2016/5613/P- Hillview, Vale of Health- Objection to Planning Application

Re ‘Applicants Response to Objections, dated 2/12/16.’

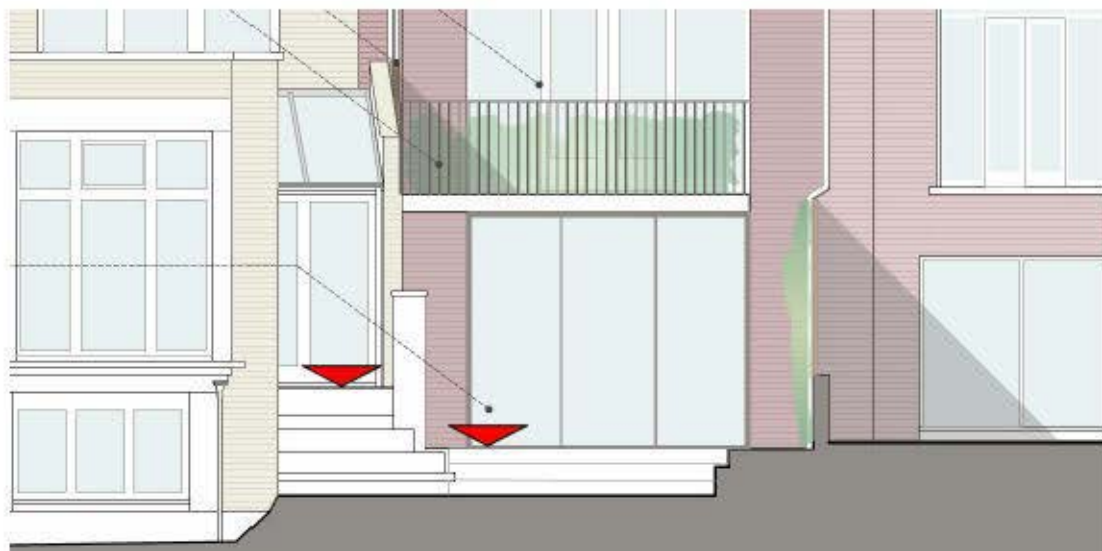
The length of wall along the boundary is less than 2m long

NOT, NOT TRUE as architects they should be ashamed of themselves unless it is a mistake or downright lie. It is 50% longer ie 3m long PLUS the long existing gable wall to the existing conservatory to be added to the 3 NOT 2m

and single storey with the room at Faircroft at a significantly elevated level, higher than both the existing and proposed lower ground floor level at Hillview, circled below for clarity. It will not impact upon outlook or any other aspect of residential amenity.

This is not true. SO NOT TRUE.

As existing the rear garden terrace to Faircroft is very narrow and to the south side an existing two storey AND three storey rear extension of considerable width blocks out a lot of light. The existing lower level Hillview conservatory allows for significant levels of light to pass through to the rear garden, particularly in the afternoon when there is no sun whatsoever on this east side of the houses. The proposals include removing the conservatory and replacing it with a one storey rear extension right up to the boundary line and a circa 1.8m high privacy screen on the roof terrace. This would result in the elevation measuring at least circa 4.2m in height. This is considered to result in a development which would detrimentally overshadow the rear garden terrace of Faircroft resulting in a sense of enclosure which would detrimentally ruin the enjoyment of the rear garden terrace for existing and future residents. This sense of enclosure would also harmfully limit the level of natural light enjoyed by the occupiers of Faircroft.
